APPLICABILITY: 2019MY Ascent “Touring” Models
SUBJECT: Rear Door Handle Frame- Design Change

NUMBER: 12-255-18R
DATE: 12/13/18
REVISED: 01/10/19

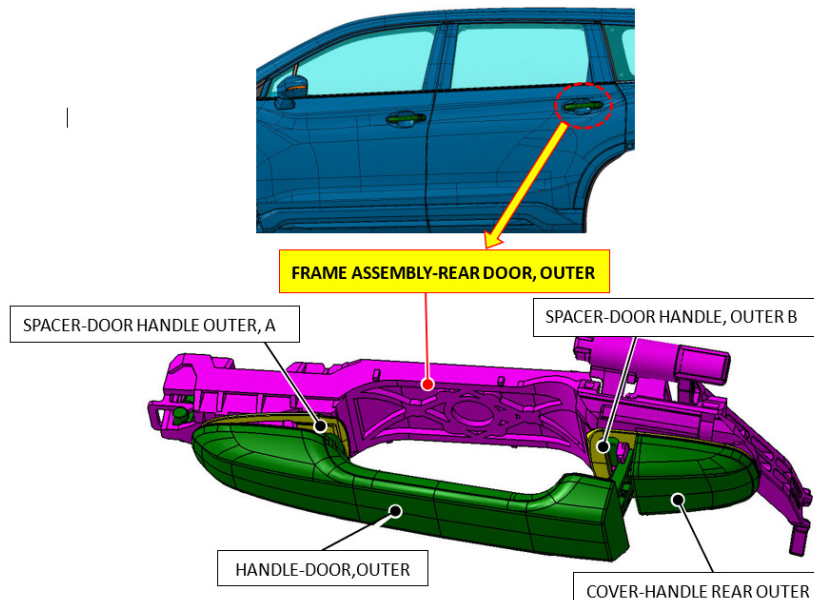
This bulletin outlines a design change made to the inner frame assembly used with the silver (“chrome”) type outer door handle to improve its reliability.

NOTE: The changes were made to the Frame Assembly, not the outer door handle. See illustration below.

The new rear door handle frame assemblies were incorporated into production starting with VIN K3445609.

Description	Part Number
FRAME ASSEMBLY- REAR DOOR OUTER RIGHT	62142XC12A
FRAME ASSEMBLY- REAR DOOR OUTER LEFT	62142XC13A
